EN010125: Application by RWE Renewables UK Dogger Bank South (West) Limited and RWE Renewables UK Dogger Bank South (East) Limited for the Dogger Bank South Offshore Wind Farms Project

The Examining Authority's Written Questions and requests for further information

Issued on 28 February 2025

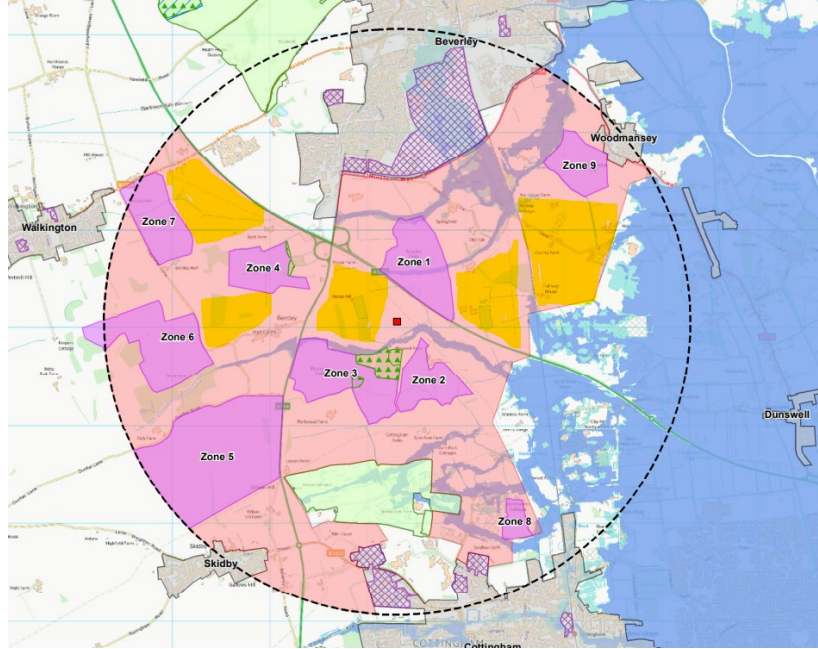
GD.1.6	The Applicants	Design and Access Statement The DAS [REP2-027 , Plate 4-7] shows the proposed converter stations with the larger footprint prior to Change Request 2. Can you update this plate, and review and update any others in the document that show the larger converter station footprint?
GD.1.7	The Applicants	Infrastructure security What consideration have you given to the protection of the proposed onshore and offshore infrastructure from acts of vandalism and the threat of terrorist attack?
GD.1.8	The Applicants	The Holford and Horlock Rules ES Chapter 4 [AS-017 , Table 4-1] refers to the Holford and Horlock Rules as applicable to the Proposed Development. With references to NPS EN-5 paragraphs 2.9.17 and 2.9.19, can you set out in detail how the Holford and Horlock Rules informed and influenced your site selection for the Proposed Development?
GD.1.9	The Applicants	Alternatives Could any existing, consented or proposed infrastructure in the offshore and onshore environments (such as that serving Dogger Bank A/ Dogger Bank B/ Hornsea Project 4 OWFs for example) be utilised for transmission of electricity generated by the Proposed Development? Can you provide evidence to support your answer?

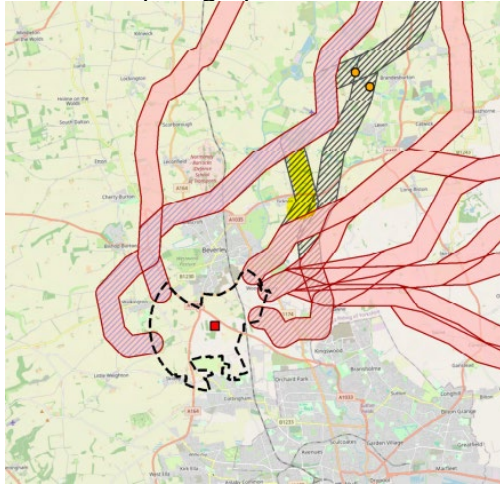
GD.1.13	The Applicants	Site selection – converter stations Why were the areas highlighted in orange below not included in the substation zone long list (map taken from [AS-011]):

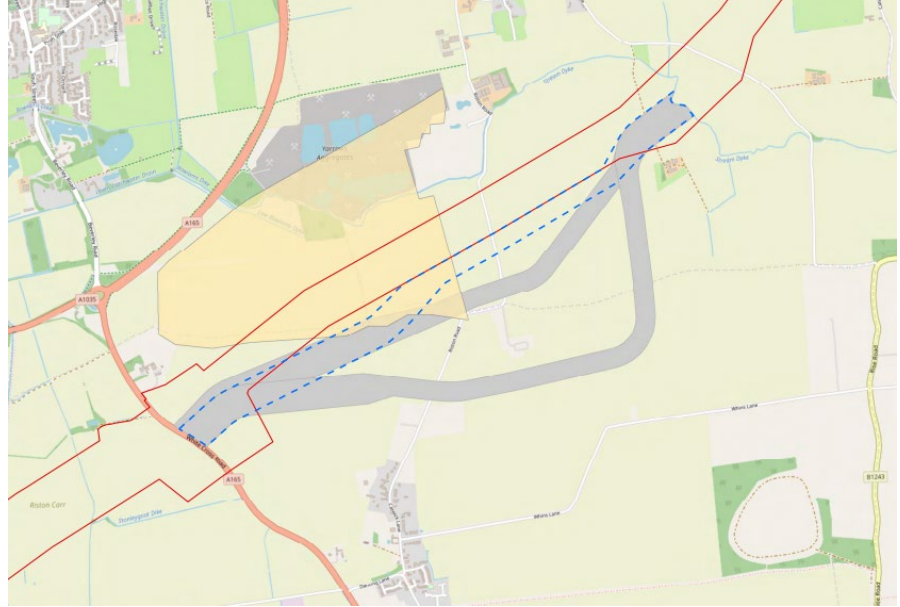
GD.1.14	The Applicants	<p>Site selection – converter stations Provide a list of constraints for Zone 4 considered during the site selection process (in the context of tables 4-11, 4-12, 4-13 of ES Chapter 4 [AS-017]) – how might this be compared to your decision to discount other converter station zones?</p>
GD.1.15	The Applicants	<p>Site selection – converter stations ES Chapter 4 [AS-017], paragraph 90] states that when the two high voltage alternating current (HVAC) options were removed from the design envelope, this left two options for the converter stations: two high voltage direct current (HVDC) converter stations in Substation Zone 4 (co-located); or, one HVDC converter station in Substation Zone 1 and one HVDC converter station in Substation Zone 4. Why was an option of two HVDC converter stations in Substation Zone 1 (co-located) not considered?</p>
GD.1.16	The Applicants	<p>Site selection – converter stations Change Request 2 reduces the maximum footprint of the converter stations. If the maximum footprint of the converter stations had been reduced at earlier stage in the site selection process, would this</p>

ExQ1	Question to:	Question
		have resulted in more of the sites discounted at the long or short list stage being considered further? Has reconsideration of other sites previously discounted for the converter stations been made following the reduction in size of the converter stations and if so, what did this identify?
GD.1.17	The Applicants	Site selection – cable route Why did the initial site selection process consider a cable corridor width of 2km? If the size of the cable route had been reduced at earlier stage in the site selection process, would this have resulted in more of the sites discounted at the long or short list stage being considered further?
GD.1.18	The Applicants	Site selection – cable route Why was the highlighted section shown from figure 4-24 [APP-068] in yellow below removed during evaluation of the long list as this section does not appear to be affected by Brandesburton ponds (in relation to paragraphs 149-152 of ES Chapter 4 [AS-017])?
